Office Action Summary	Application No. 10/593,303	Applicant(s) VAN MOL ET AL.	
	Examiner WALTER H. SWANSON	Art Unit 2823

DETAILED ACTION

Fig. 8

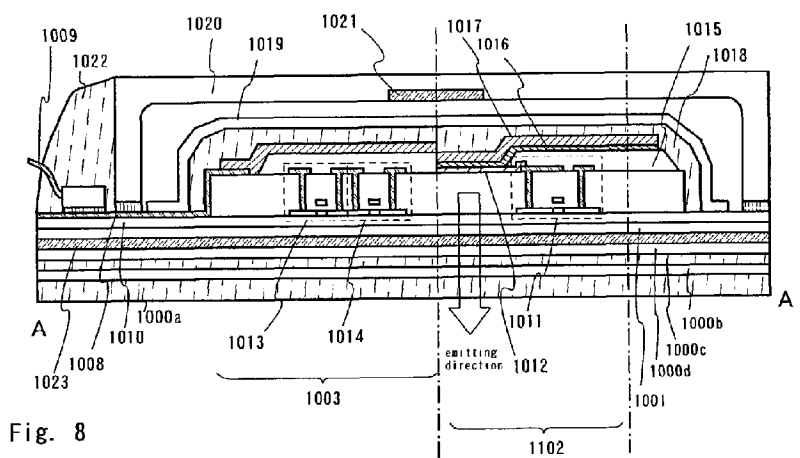
Yamazaki **teaches** depositing multiple layers to form a barrier (1000b) capable of preventing water and oxygen from penetrating into an organic active layer (Fig. 8).

Yamazaki discloses the claimed invention except for the water and oxygen permeability ranges. It would have been obvious to one having ordinary skill in the art at the time the invention was made to form a barrier with water and oxygen permeability ranges of less than $0.01\text{g/m}^2/\text{day}$ and $10^{-2}\text{cc/m}^2/\text{d}$ respectively, since it has been held that where the general conditions of a claim are disclosed in the prior art, discovering the optimum or workable ranges involves only routine skill in the art. *In re Aller*, 105 USPQ 233 (CCPA 1955).
